GADOLINIA FUEL PROPERTIES
FOR LWR FUEL SAFETY EVALUATION

This Supplement to Topical Report XN-NF-79-56, Rev. 1, "Gadolinia Fuel Properties for LWR Fuel Safety Evaluation," provides ENC's responses to the additional information needs transmitted in the NRC's letter (R. L. Tedesco to G. F. Owsley) dated January, 1981. Each NRC identified item is repeated in the text, followed by ENC's response.

XN-NF-79-56(NP),
Revision 1
Supplement 1

Figure 1.1 Gadolinia Rod Photomicrograph, X/L = .2

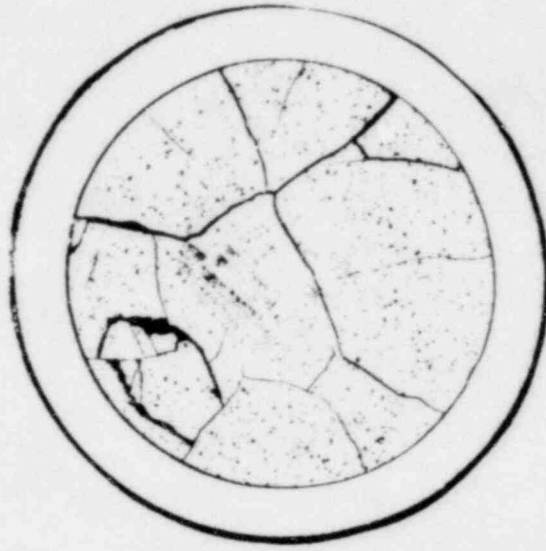
- 490.1 (a) Wada, Noro, and Tsukui (Topical Report Ref. 4) noted anomalous microstructure of irradiated $UO_2-Gd_2O_3$ as compared with irradiated UO_2 . To what extent have the microstructures of irradiated Exxon $UO_2-Gd_2O_3$ pellets been examined ceramographically for potential anomalies, Gd_2O_3 redistribution, etc. (e.g., how many rods were examined, what burnups had they reached, what power levels were the rods operating at, what Gd_2O_3 concentrations were in the pellets, and what observations were made)? If the Exxon $UO_2-Gd_2O_3$ pellets were to exhibit the anomalies reported by Wada, et al., what potential effects might that have on poison rod performance? To what extent might the vastly different isotopic composition of Gd employed by Wada, et al. (91% Gd-160) compromise the applicability of their results to Exxon $UO_2-Cd_2O_3$ poison?

To date, two ENC UO_2 - Gd_2O_3 fuel rods have been subject to detailed destructive examination. The rods came from ENC 9x9 assemblies irradiated in the Big Rock Point boiling water reactor. The rods contained 1.0 w/o gadolinia bearing pellets. They attained a peak pellet burnups of 25,000 MWD/MTM and experienced peak power levels of about 12.0 kw/ft. Each rod was cut at a number of axial locations for detailed microstructure examinations. Figures 1.1 and 1.2 show representative photomicrographs from one of the rods. Figure 1.1 is from an axial cut just below the quarter core elevation at

$X/L = 0.2$, and is a location where peak power was experienced. Figure 1.2 is from mid-core height, $X/L = .5$, and corresponds to a region of where peak power levels were lower than in Figure 1.1. The microstructure in these figures shows no evidence of the discontinuous grain growth reported by Wada. The only noticeable features in these photographs are the typical cracking patterns and the slight darkening towards the center of Figure 1.1. This darkening marks a region of high temperature sintering and loss of porosity. The rod power level was not high enough to have expected any columnar grain growth.
